Detailed Site Plan Departure of Parking and Loading Standards The Cassidy

DSP-21045
DPLS-22002

STAFF REPORT

SUBJECT: Detailed Site Plan DSP-21045
Departure of Parking and Loading Standards DPLS-22022
Type II Tree Conservation Plan TCPII-077-04-03
The Cassidy

Figure 1: Site Plan

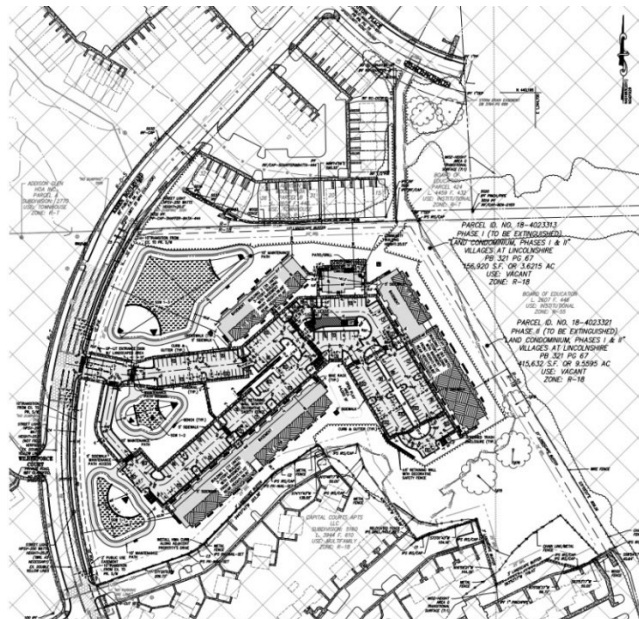
6. **Design Features:** The proposed application is for development of 175 multifamily units within 3 buildings. Each building will be 4 stories and approximately 51 feet tall at its highest elevation. The site will be accessed from a single entrance along Karen Boulevard. Building 1 will contain a total of 77 dwelling units, Building 2 will contain a total of 63 dwelling units, and Building 3 will contain a total of 35 dwelling units. The clubhouse will be 3,596 square feet and located within Building 3. A total of 263 surface parking spaces are provided and the site will have 1 loading space. A companion Departure from Parking and Loading Standards (DPLS-22002) has been filed in conjunction with this DSP to allow for the reduction in 168 parking spaces. SWM facilities will be provided on-site near the entrance and adjacent to Karen Boulevard.

Pole-mounted lighting is proposed throughout the parking lot, and building-mounted lights are provided at all doors. A photometric plan was submitted with this application and reflects adequate lighting throughout the site with minimal spillover onto adjacent neighboring properties. Staff recommends approval of the lighting, as proposed.

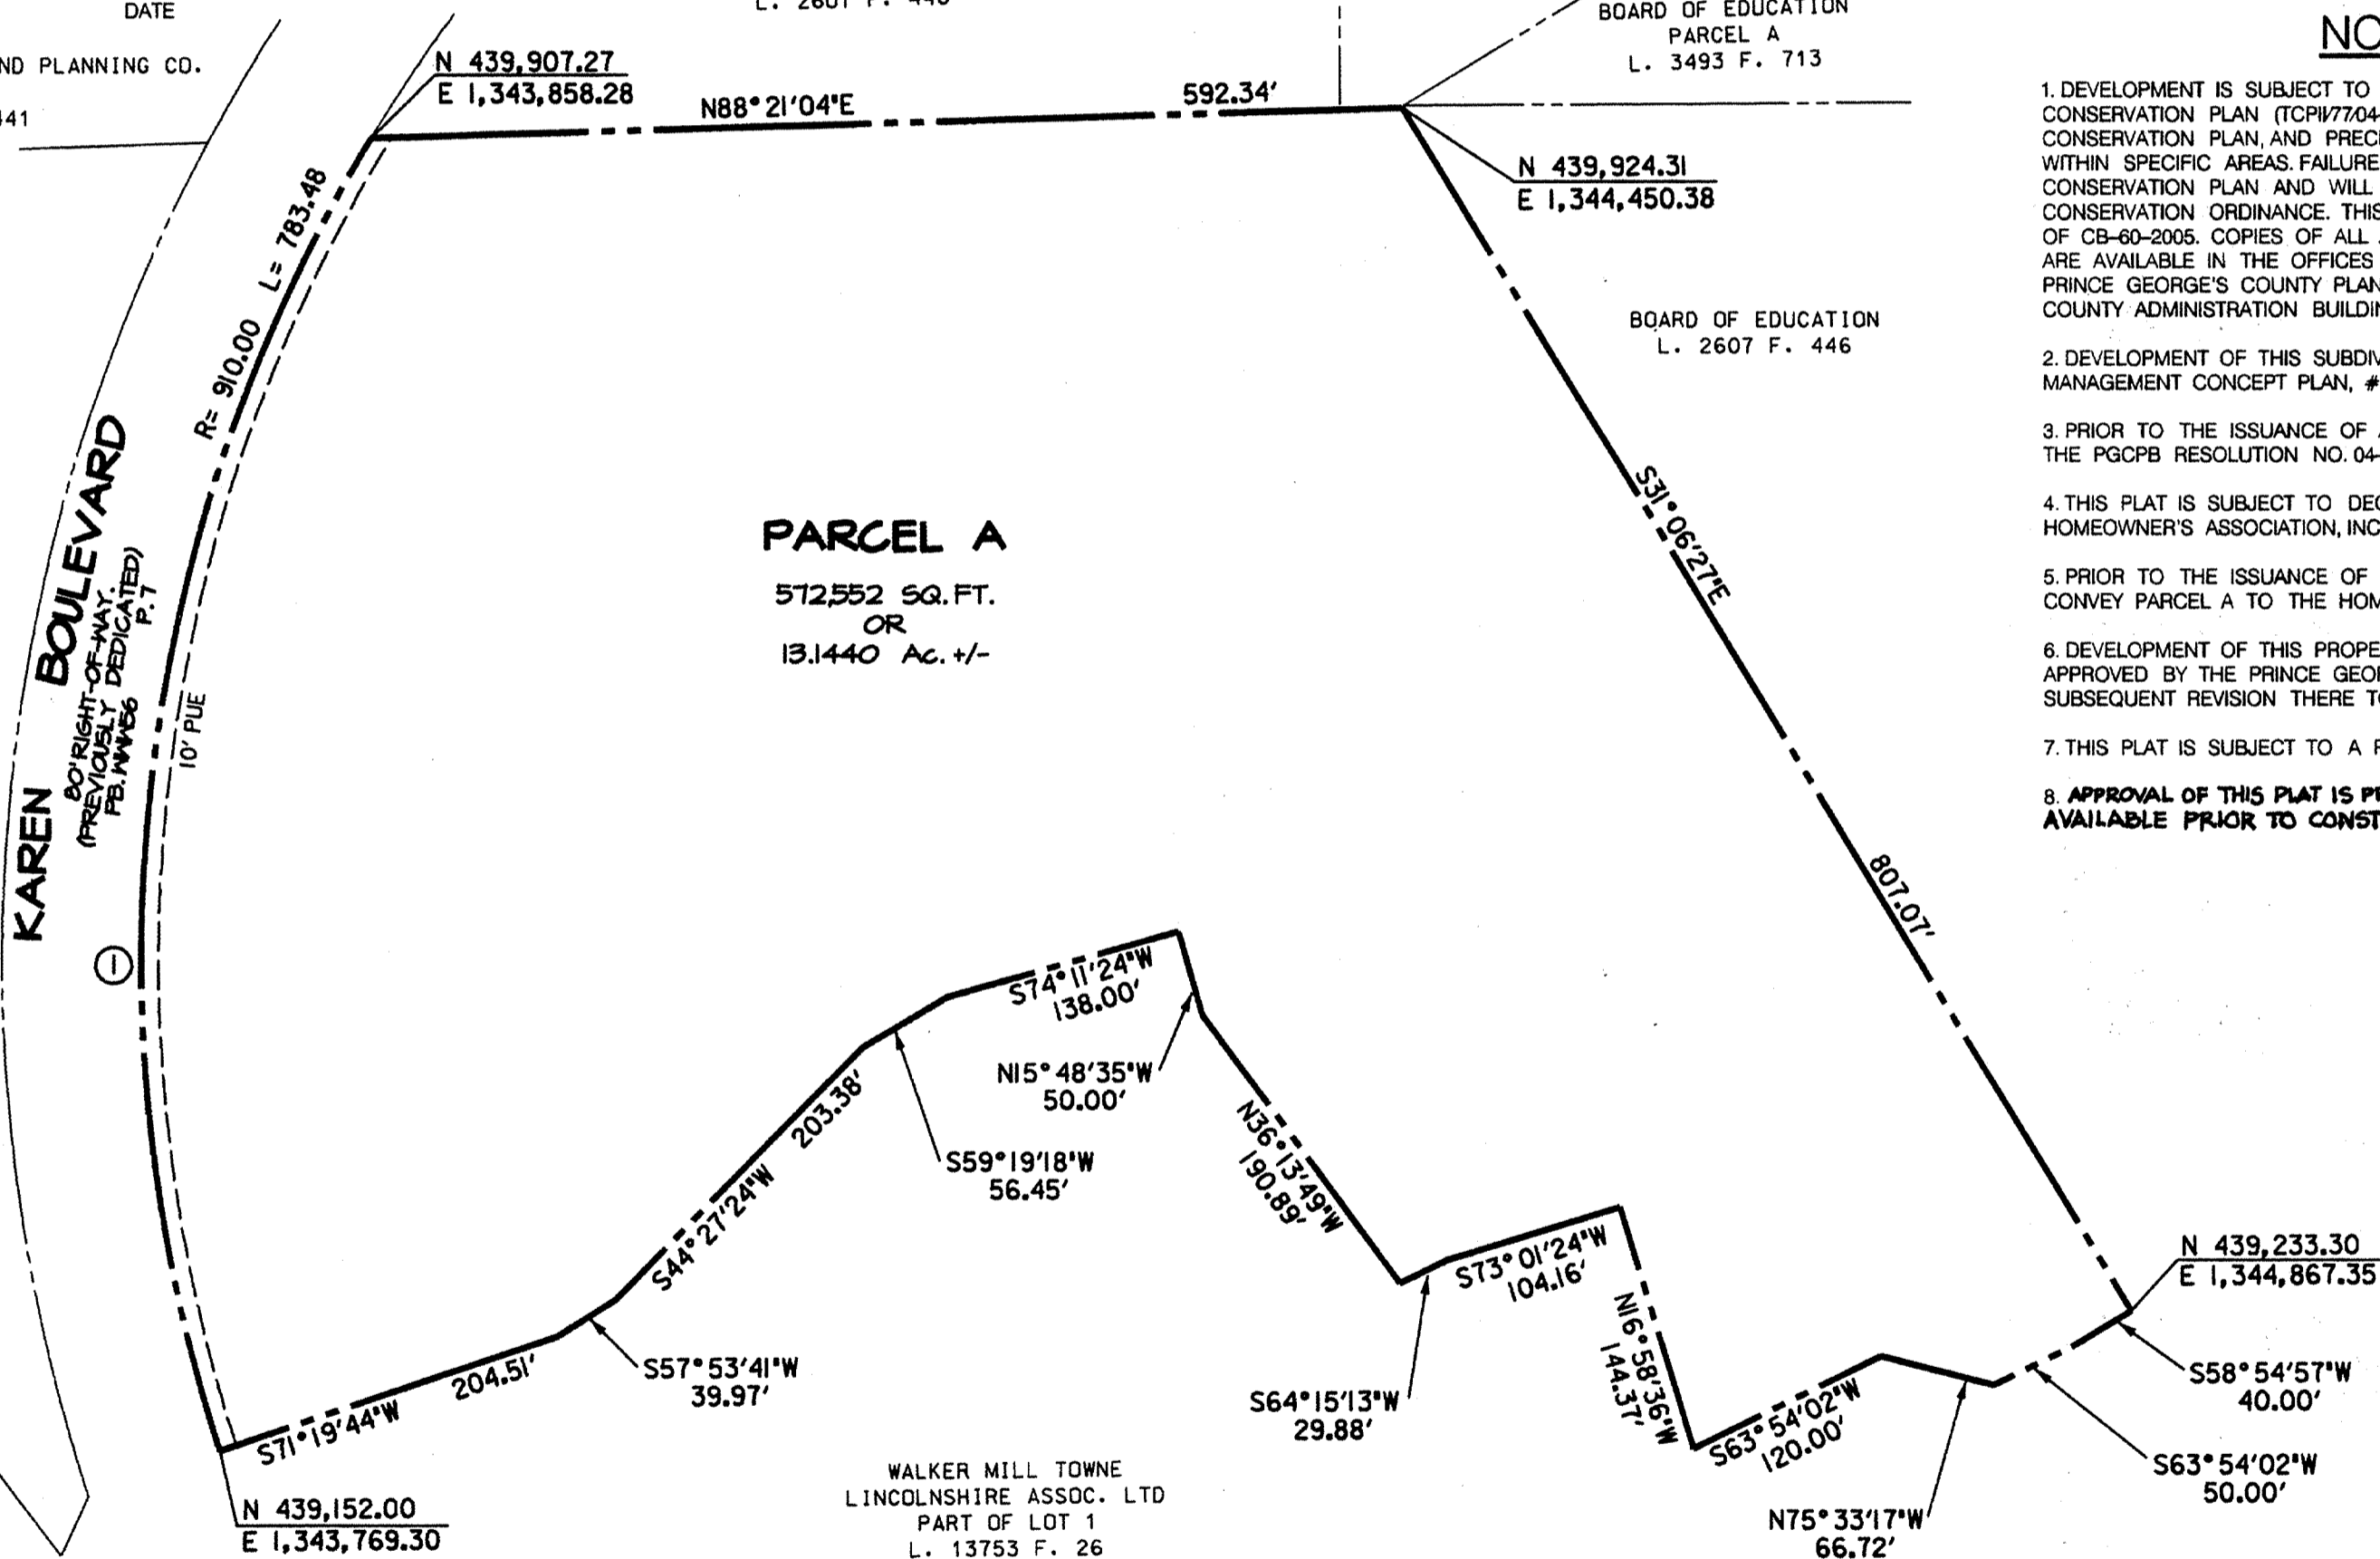
PM 220-93 does not show the conservation easement and the above-referenced note is not reflected on the plat. The Type II tree conservation plan (TCPII) does not depict an area of conservation located on Parcel A. The Environmental Planning Section has reviewed this and recommends approval with conditions.

2. Prior to approval of any building permit, the applicant and the applicant's heirs, successors, and/or assignees shall submit a plat of correction to correct the property's boundary bearings and distances and remove Note 5 of the existing Plat Book PM 220-93.
